# Florida Power

CORPORATION  
Crystal River Unit 3  
Docket No. 50-302

June 14, 1997  
3F0697-10

Subject: Technical Specification Change Request Notice 210

# SOLUTION SET FLOW PATH

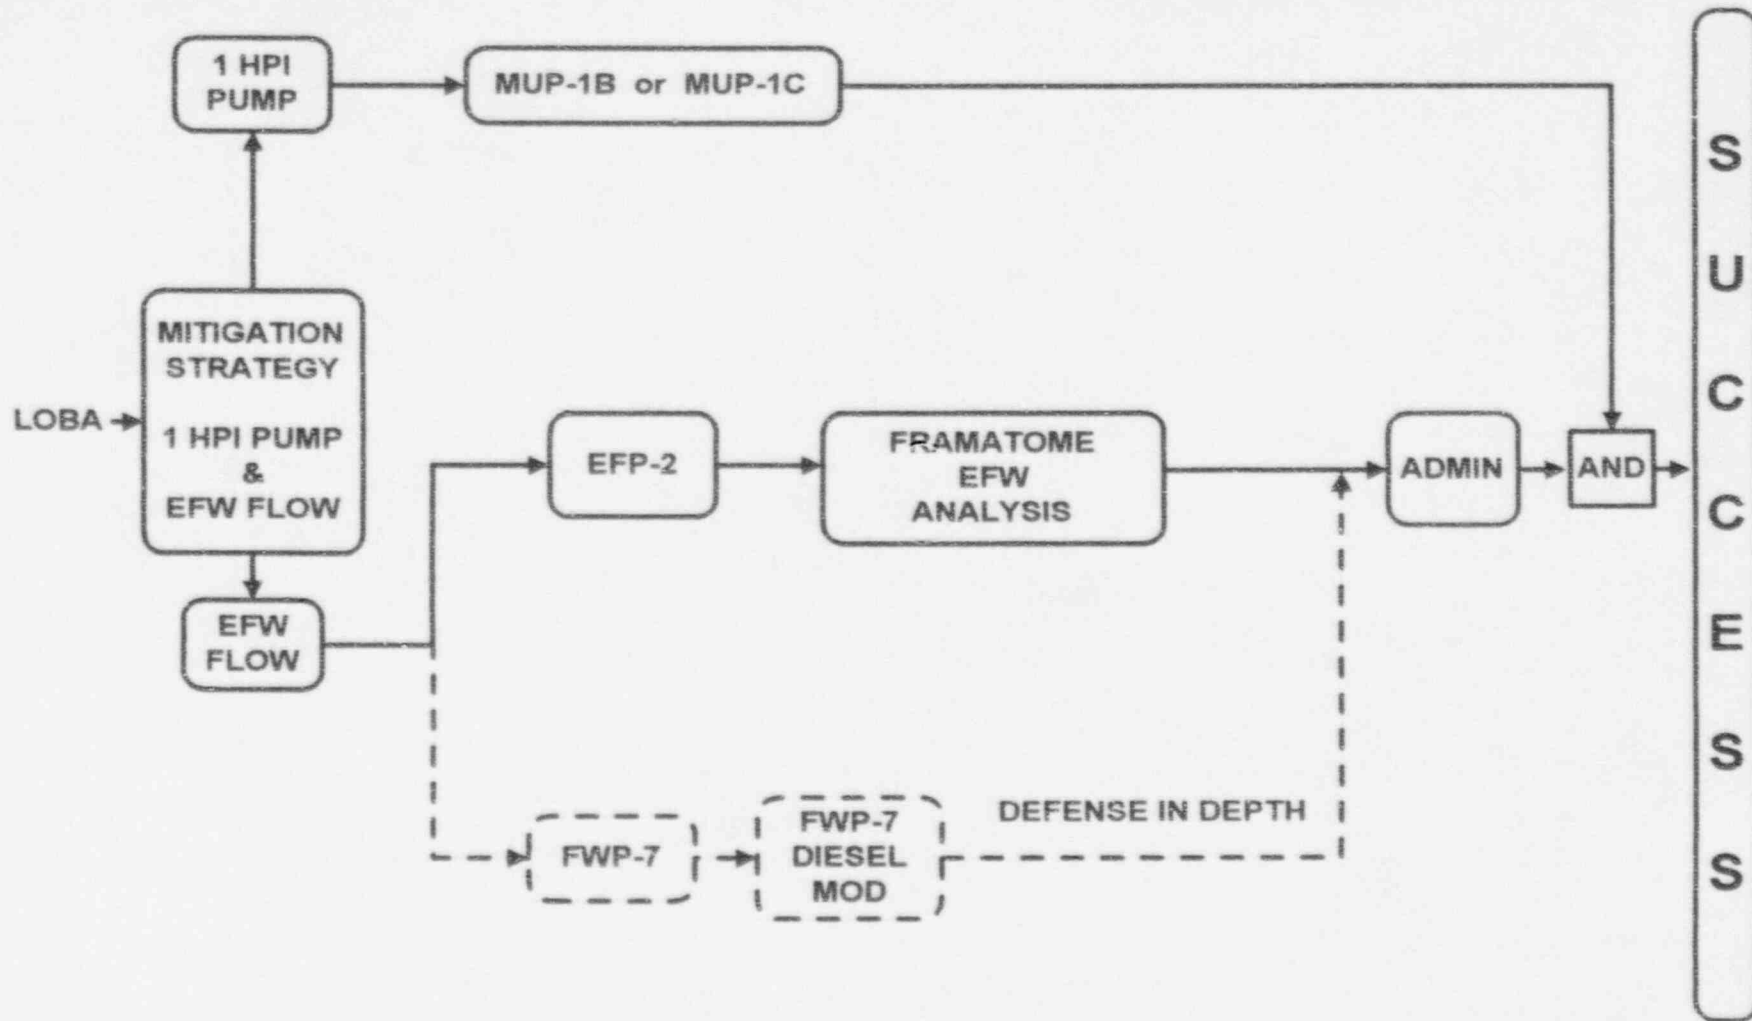
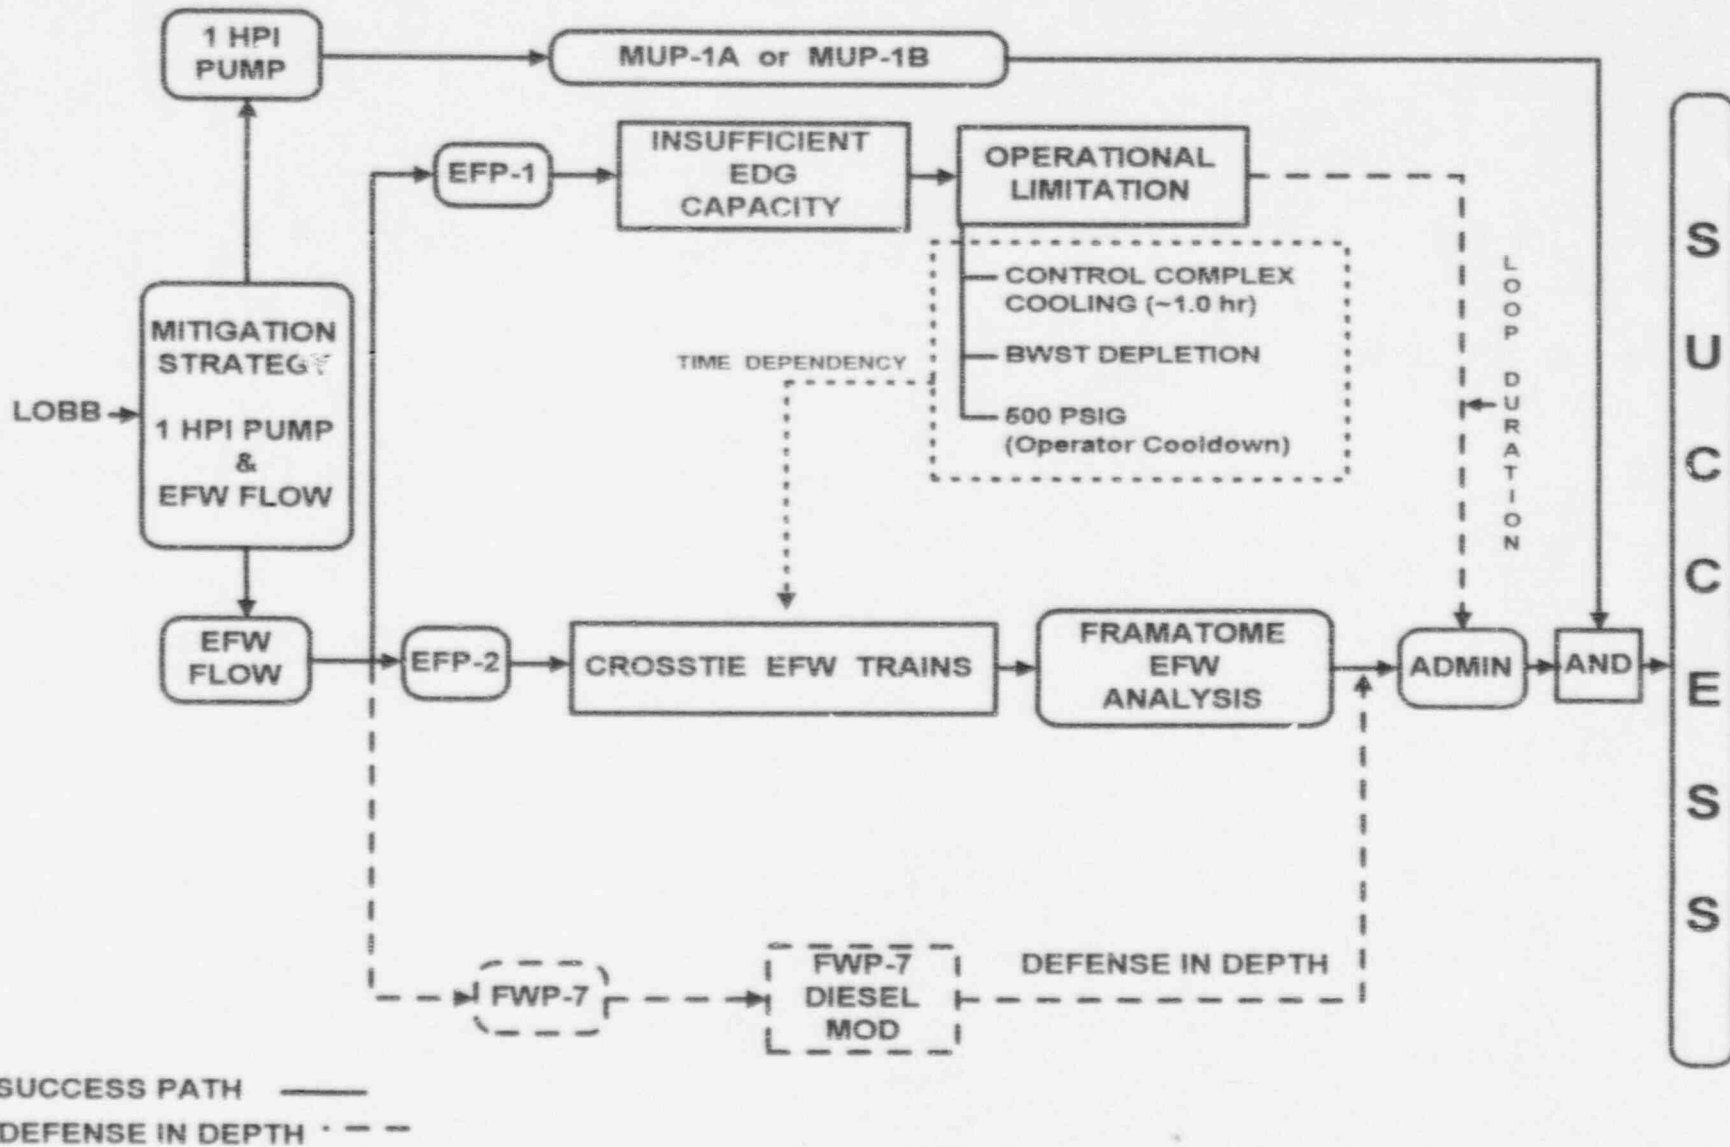
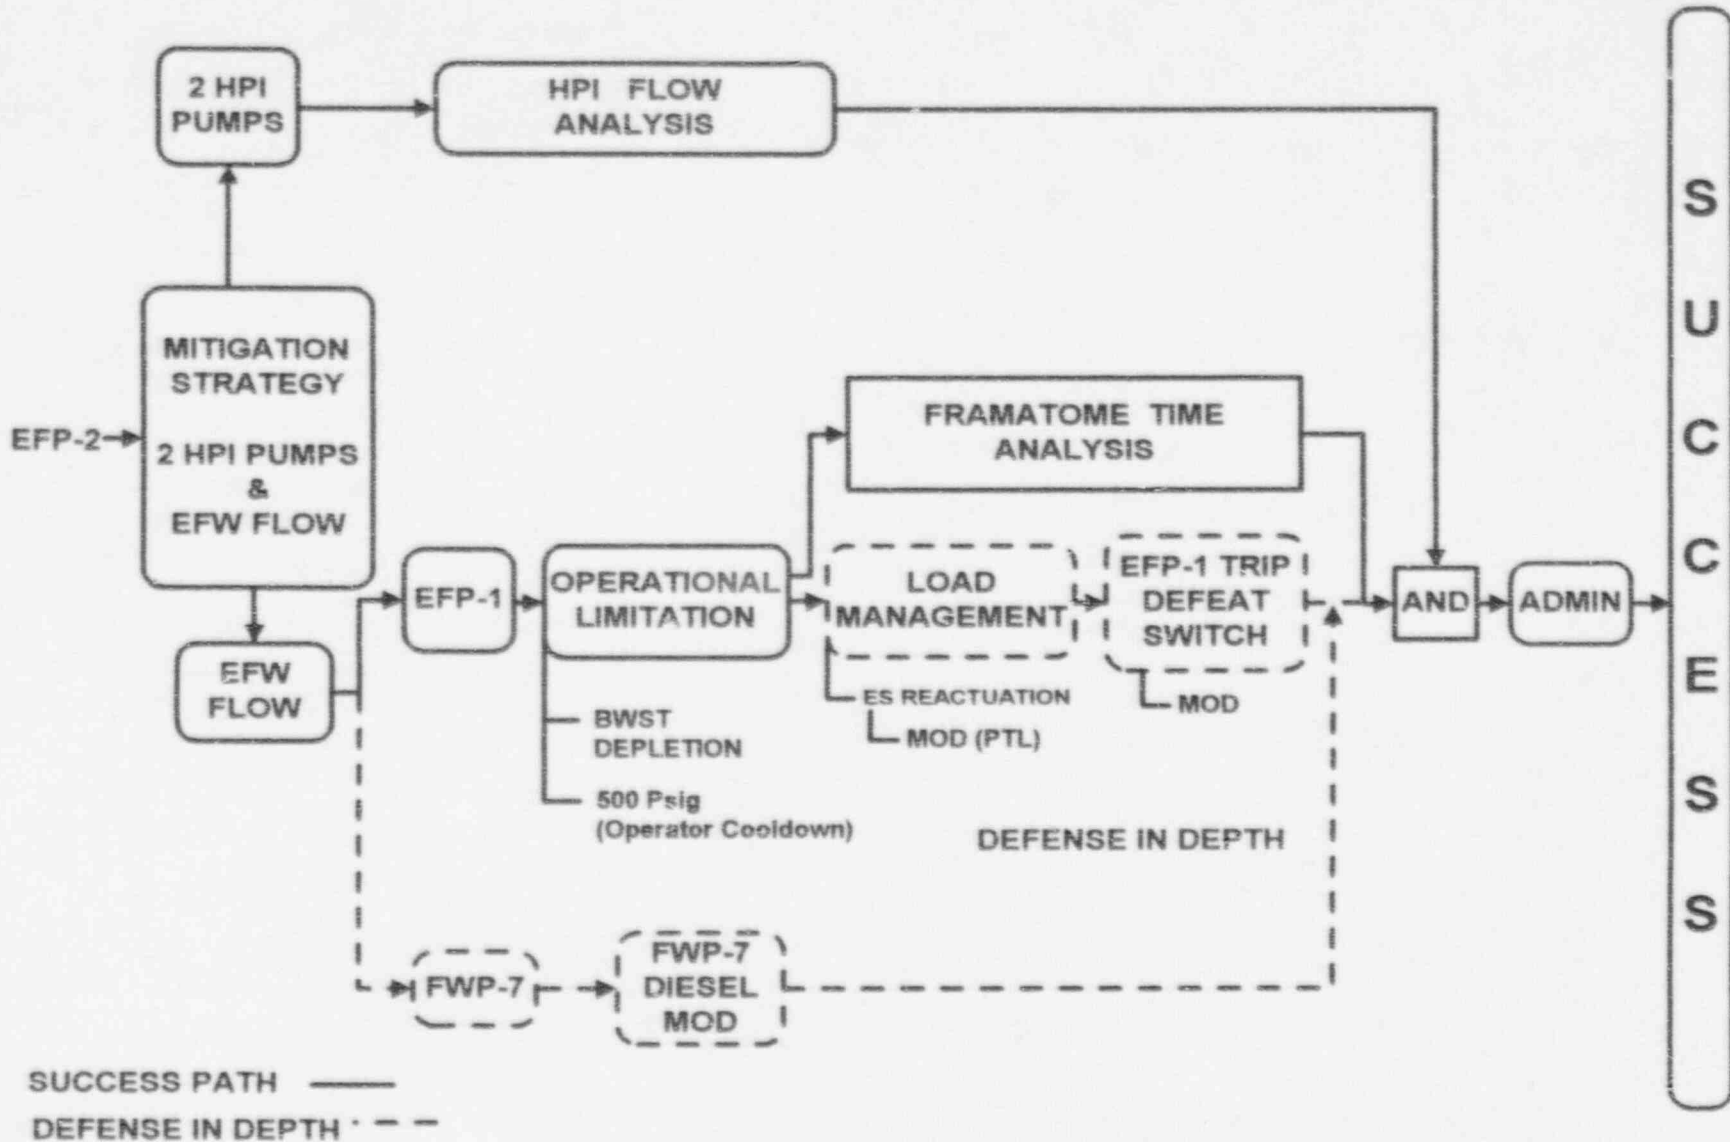
SBLOCA with a concurrent LOOP and specific single failures challenge successful accident mitigation. The installation of certain modifications and procedure changes improve accident management response for the identified accident scenarios regardless of the probability of occurrence. The mission time for EFW is a function of several independent variables such as decay heat load, break size and location, and HPI flow. EFW will be maintained for those SBLOCAs that require OTSG cooling.

For a LOBA or LOBB, 1 HPI pump and EFP-2 are available to provide adequate core cooling. For the LOBA, CC cooling is provided by the 'B' train chiller. For the LOBB, EFW will be cross-connected within 1 hour to provide controlled EFW flow from EFP-2 to both OTSGs which also supports securing EFP-1 to operate the 'A' train chiller for CC cooling. Both scenarios require EFW for approximately 35 hours. Procedures will provide guidance needed to manage EFP-2 throughout the accident. For a single failure of EFP-2, EFP-1 and 2 HPI pumps are available to provide adequate core cooling. Procedural guidance will prevent the loss of EFP-1 before it is no longer needed to support OTSG cooling.
